## REMARKS

Applicant acknowledges the Office Action dated June 13, 1995, in which the Examiner rejected all claims pending in the application and objected to the Drawing and specification for several reasons. Applicant has amended the application and respectfully traverses the objections and rejections for the reasons set forth below.

FIG. 1

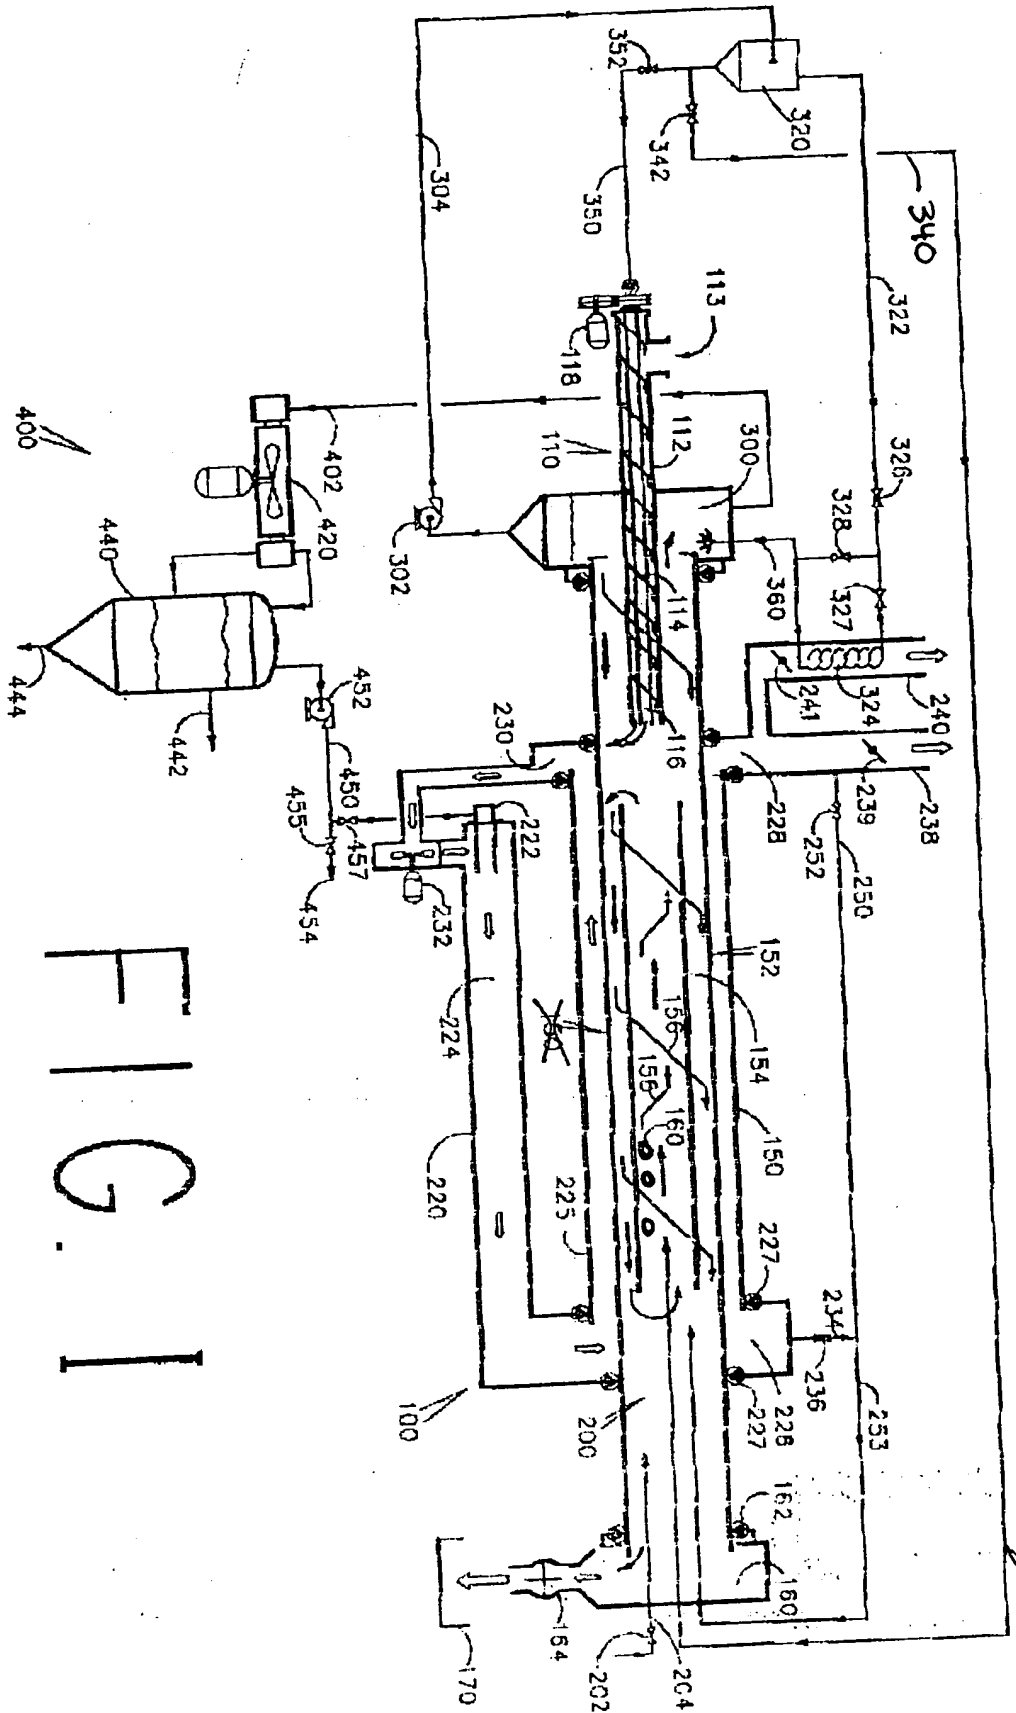
Applicant has submitted herewith a Proposed Drawing Amendment, in accordance with the Examiner's suggestion, and submits that the grounds for objecting to the drawings have been eliminated. The reference numeral "253," which refers to the stream of exhaust gases, has not been added to the Figure, as it appears in the original Figure, near the right-hand side.
